clee Bits rate control update

This hardware and software update to the clee Bits module adds a third mode to the RATE control. The 3 modes are AUDIO RATE, SUB-AUDIO RATE and a new EXTERNAL TRIGGER MODE

WITH MOD:

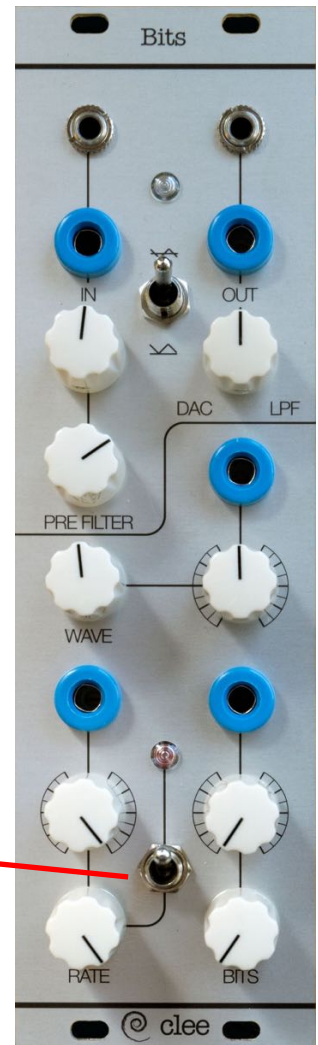
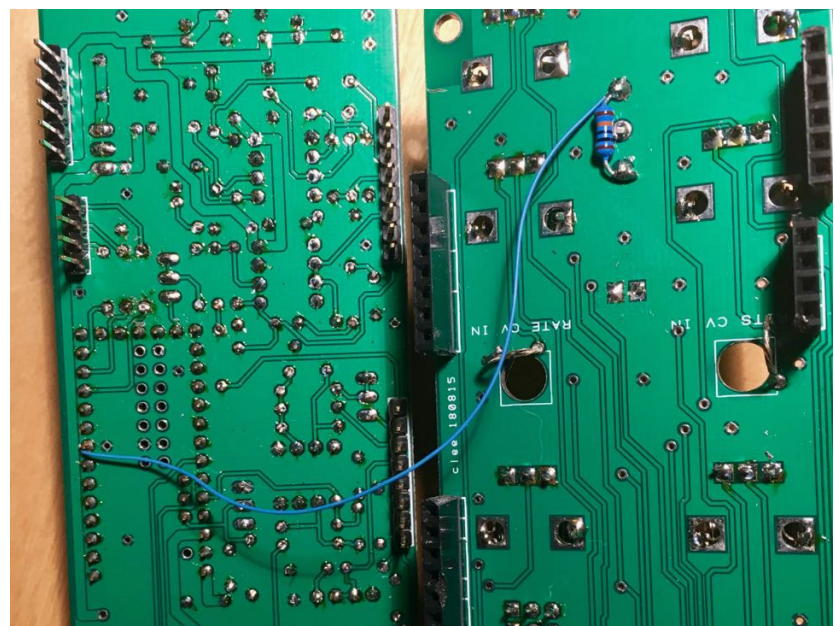
ORIGINAL DESIGN:

UP: Audio rate - LED is off

DOWN: Sub-audio - LED flashes sample rate

UP: EXTERNAL TRIGGER - LED is on when input is above threshold

CENTER: Audio rate - LED is off

DOWN: Sub-audio - LED flashes sample rate

RATE SWITCH

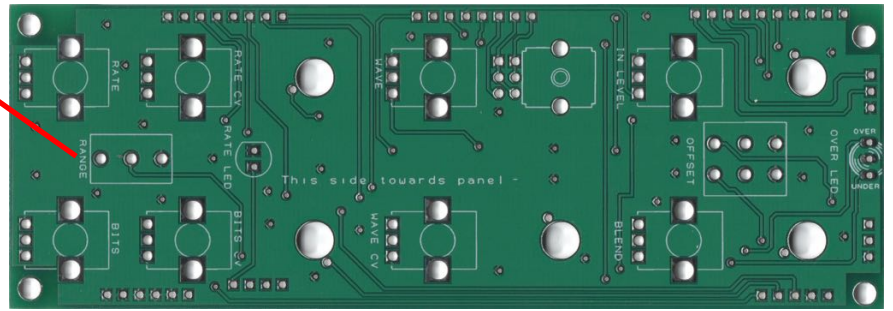
With external triggering the RATE CV IN becomes a TRIGGER IN.
Start with the RATE CV pot fully CW and the RATE MANUAL CONTROL fully CCW

The update involes using an ON-OFF-ON switch instead of ON-OFF (or replacing if updating a current build), installing a ~~100K~~ 33K resistor, and adding a jumper wire between boards.

Locate the range switch on the PCB.

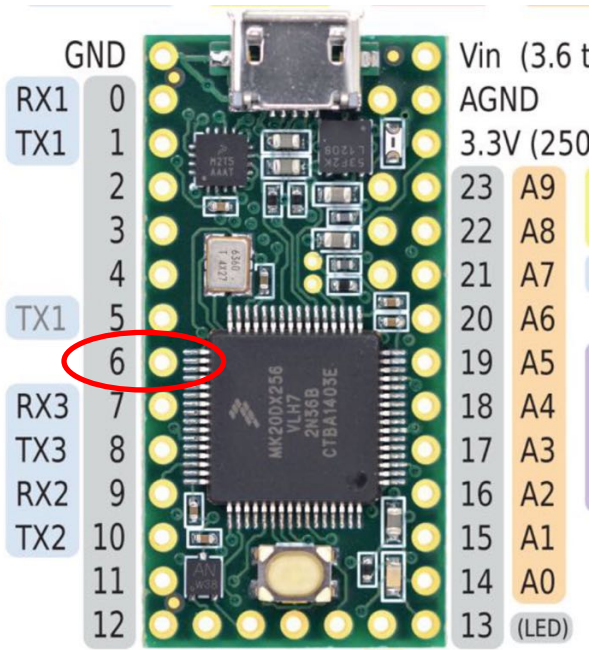
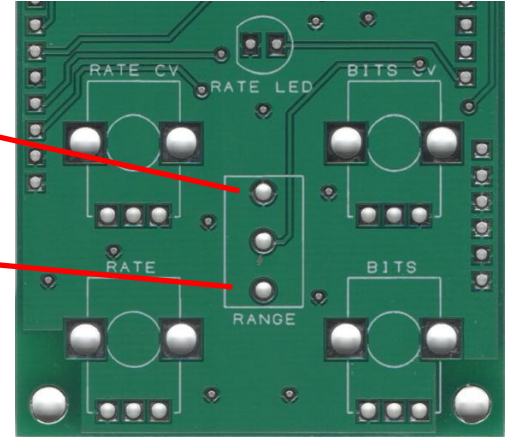
You should have installed 3 position ON_OFF_ON switch

One side of the switch is ground and the other is no connection

ground connections with thermal relief pads

No connection

IMPORTANT!
You are connecting a jumper wire to PIN 6 of the Teensy 3.2.

This is actually PIN 8 of the Teensy board, Pin 1 is ground and PIN 2 is Teensy PIN 0

1) Connect the jumper wire to the Teensy pin 6 (board 8)

2) Solder a ~~100K~~ 33K resistor between the outer lugs of the range switch

3) Connect the other end of the jumper wire to the pin of the switch that was no connection

4) Program the module with software version 1.4
